## LINCOLN CITY/LANCASTER COUNTY PLANNING STAFF REPORT

for May 11, 2005 PLANNING COMMISSION MEETING

**P.A.S.:** Change of Zone #05004 Pine Garden PUD

**PROPOSAL:** Change the zoning designation from AG to R-3 PUD, and approve a development plan for 28 dwelling units and 22,000 square feet of commercial floor area.

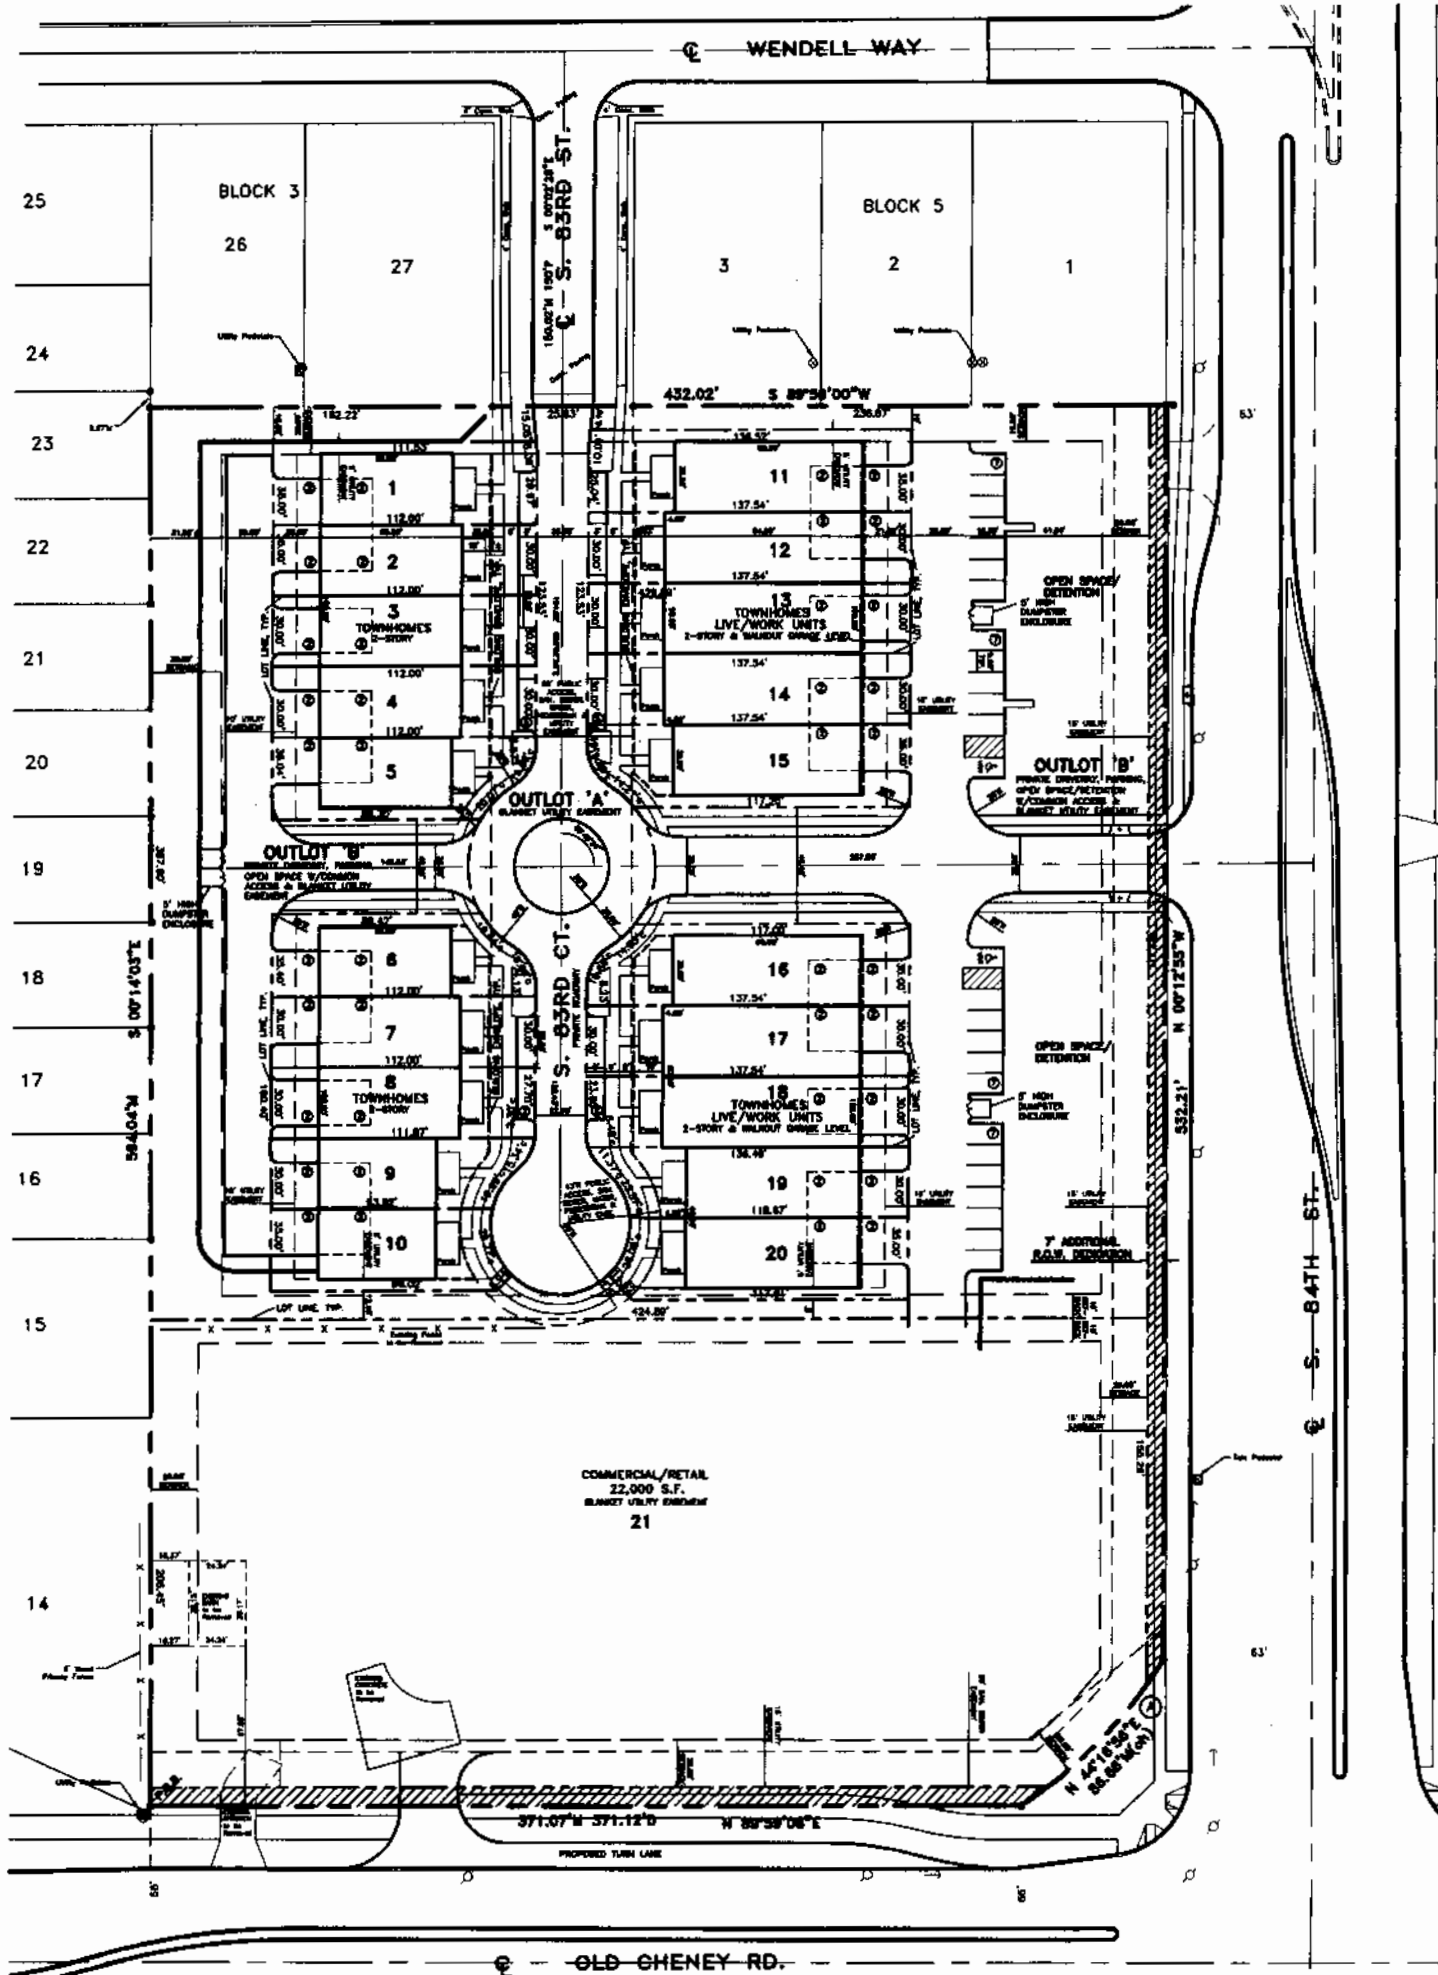
We have revised the plans to remove the site details from Lot 21. We are noting the maximum square footage that is allowed. However, no specifics are shown or more importantly, prohibited at this time.

General note #18 has been revised as follows;

"The owner of Lot 21, the commercial designated portion, shall come forth with a specific use to be approved by the City Council at such time, and use not be unreasonably prohibited."
